# City of Alexandria, Virginia

#### **MEMORANDUM**

ENC #2016-0009, 119 KING STREEET (DOCKET ITEM #7)

Docket Item # 10 BAR CASE # 2016-00265

Figure 2: retractable awnings at Chadwick's in Old Town, Alexandria, provided by Thomas Shade Inc.

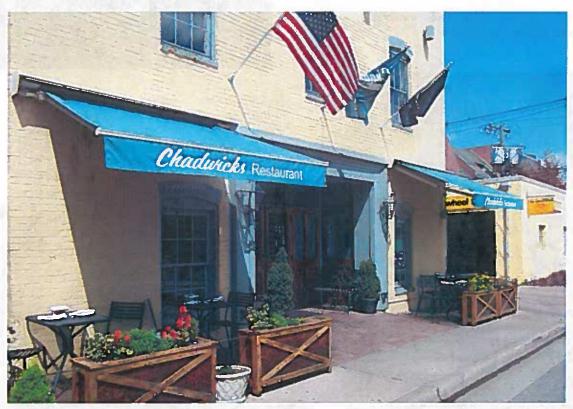
The method of affixing the shed frame to the wall (bolting) also suggests a high level of permanence. Staff recommends the alternative of a retractable awning in order to keep the historic building visible. The applicant's contractor, Thomas Shade Inc., has supplied Chadwick's Restaurant at 203 South Strand Street with such retractable awnings (Figure 2).

Rendering 1

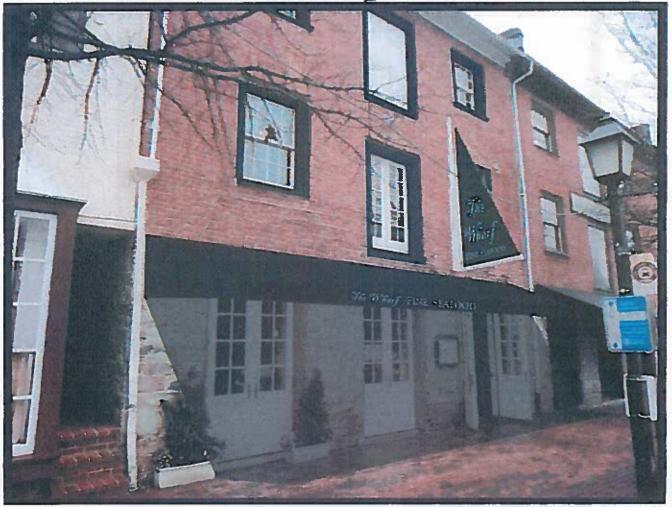
- 1. Approval of the proposed signs, awning fabric and color.
- 2. The use of a retractable rather than a fixed frame awning. The awnings must be retracted when the outdoor dining area is not open for use by customers.

- 3. If the BAR approves a rigid, fixed frame awning, staff recommends that the awning have a loose valance and open ends and that the frame be painted black.

- 4. The awning may project no farther than five feet, six inches (5'-6") from the face of the building, subject to approval of an encroachment ordinance by City Council.

- 5. The awning must have an eight foot (8') clearance from the sidewalk to the bottom of awning fabric/material at any point. The upper portion should be mounted no lower than ten feet (10') from ground level to stay below the sill of the loading door at the second floor.

- 6. All care must be taken not to damage the exterior fabric of the building when installing the awning frame. The awning frame may not be installed directly into masonry but shall be mounted through mortar joints.
